WRITTEN COMMENTS TO SCOPING MEETING FOR WEST PARCEL SOLAR PROJECT, JUNE 7, 2017

UNITED WALNUT TAXPAYERS PRELIMINARY REVIEW OF NEGATIVE GEOTECHNICAL AND GEOLOGICAL ASPECTS OF CONSTRUCTING EARTHFILL PAD FOR A SOLAR FARM ON THE WEST PARCEL - DRAFT

Attachment Google Earth Image of Existing Landslide at West Parcel Site

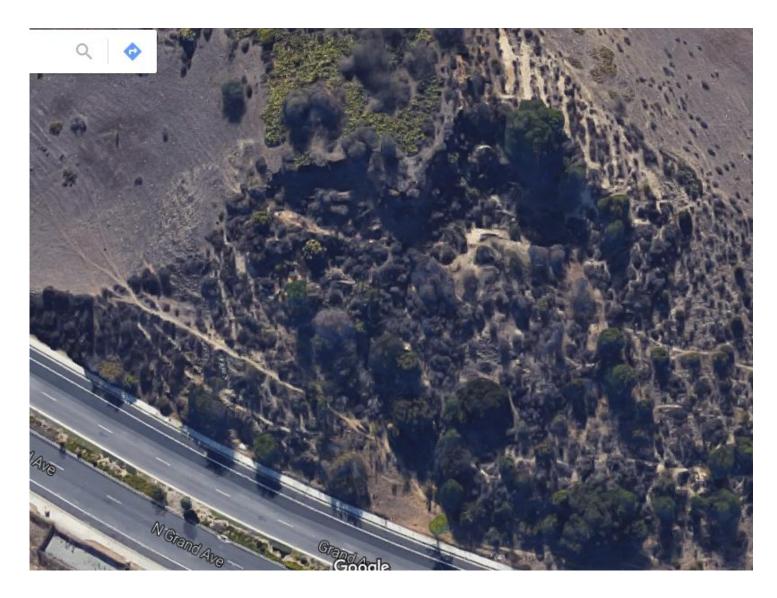
vii. The Converse report did not recognize a significant landslide in the central hill of the project site present for more than thirty years (see Google Earth attachment), which is vulnerable to further sliding.

iv. Aerial imagery from Google Earth clearly indicates landslide(s) exists on the eastern side of the central knob descending down to Grand Avenue (see attachment). The landslide area on the central hill is present in aerial imagery dating from after 1980 until the present.

v. The above referenced landslide is further validated through field visits to the site by our Engineering Geologist and former City officials with first-hand knowledge of at least two landslides that occurred at the subject site after Grand Avenue was expanded to four lanes.

vi. At least one of the above landslides at the central hill of the site closed the road (Grand Ave.) and covered all the lanes. In addition, siltstone and shale bedrock with eastward dipping bedding subject to landsliding was observed in this area.
